SERVICE BULLETIN

SB-08-200

Subject: BENDIX SR-5 VALVE Recall – INTERIM NOTIFICATION

This is to inform you that Utility Trailer Manufacturing Company notified the National Highway Traffic Safety Administration (NHTSA) of the start of a voluntary Non-Compliance campaign involving the Bendix® SR-5™ Spring Brake Valve which was installed on Utility trailers. The recall has been assigned number **16E045**.

Valve Identification

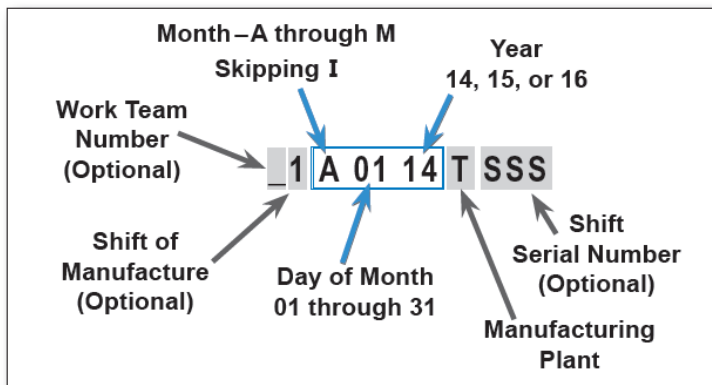
The Bendix SR-5 valves covered by this campaign can be identified by the supplier code and the date of manufacture located on the valve body. Verification of both is required to determine if the valve is a part of the campaign. Valves covered by this campaign must meet the following criteria:

1. The supplier code—"IKD"—cast in the body and located as shown in the illustration above; and
2. The date of manufacture between January 1, 2014 and March 4, 2016, inclusive. To verify the date code see *Interpreting the Date Code* below.

Sectional view of check valve assembly in seated position

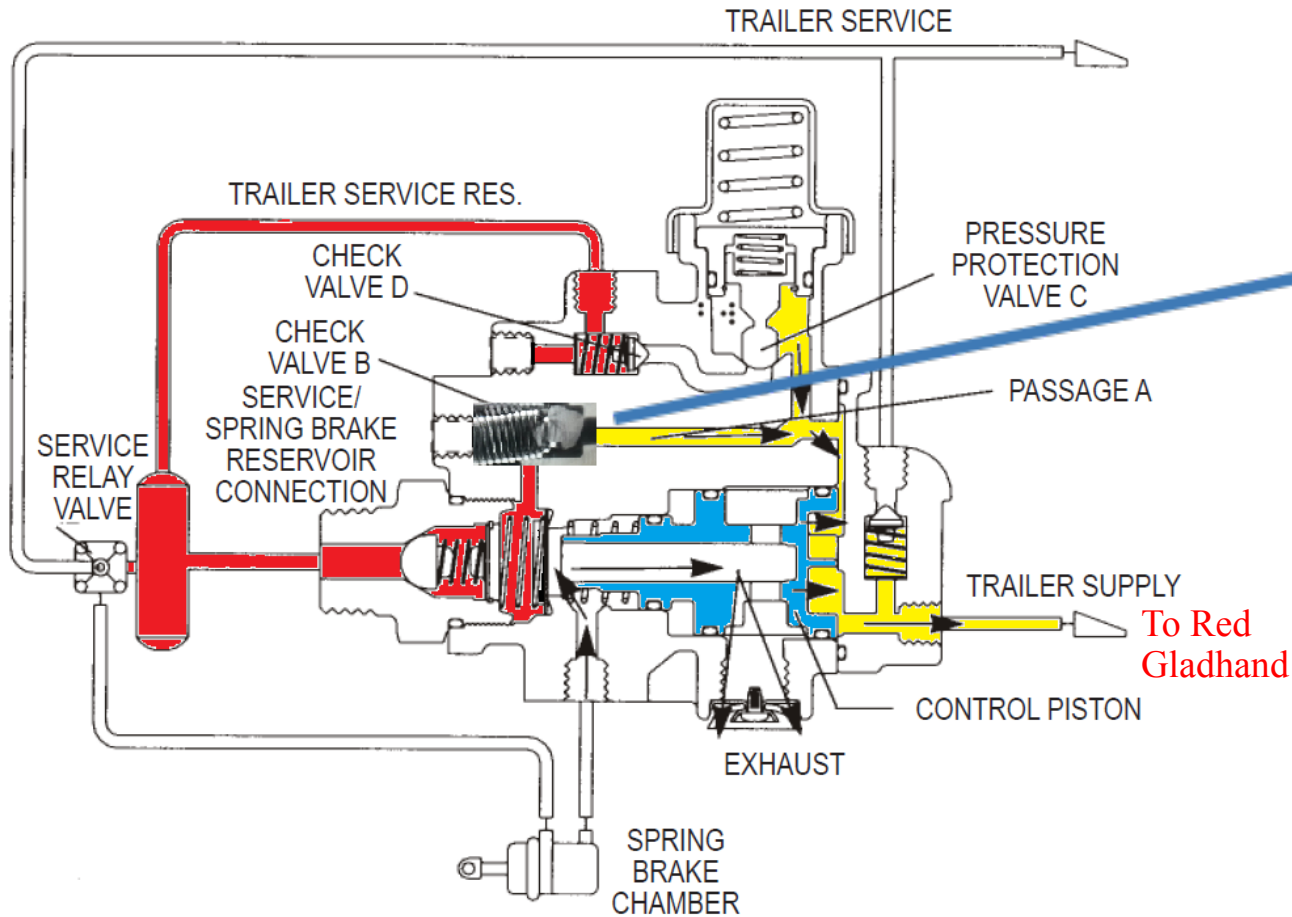
Missing Radius on Aluminum valve Body

When combined with certain field conditions – causes misalignment of internal Check Valve

Caught on Sharp Edge

Missing Radius on Valve Body

Check Valve seat
(Radius Present / Radius Not Present)

If Valve becomes Misaligned, Leakage can be Large enough to cause 'Slow to Park'

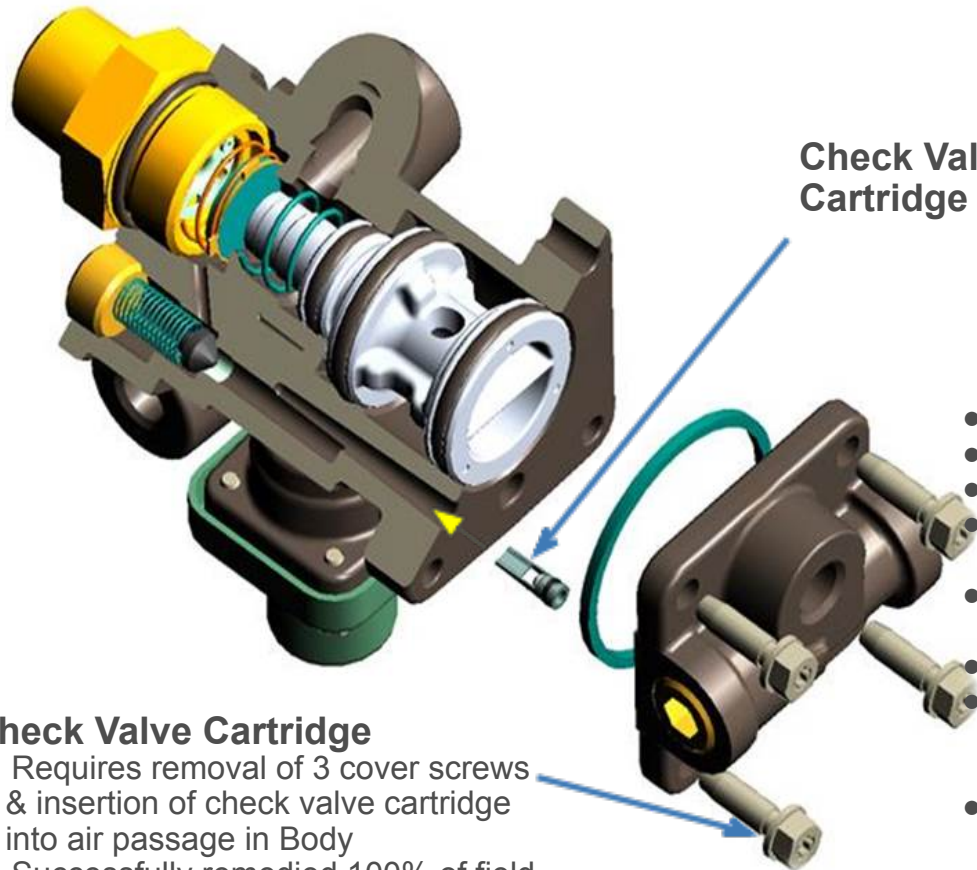
If Leakage is present (& large enough), the leaking air provides enough back pressure on the main control piston (**BLUE**) to prevent normal movement.

If the main piston does not move, immediate exhaust (<3 seconds) cannot happen.

This is how the leakage from the check valve is causing the ‘slow to park’ condition.

Once leakage fully exhausts tank pressure, the backpressure drops, the main piston moves & the trailer parks.

Missing Radius (combined with other conditions) can cause leakage – preventing immediate parking
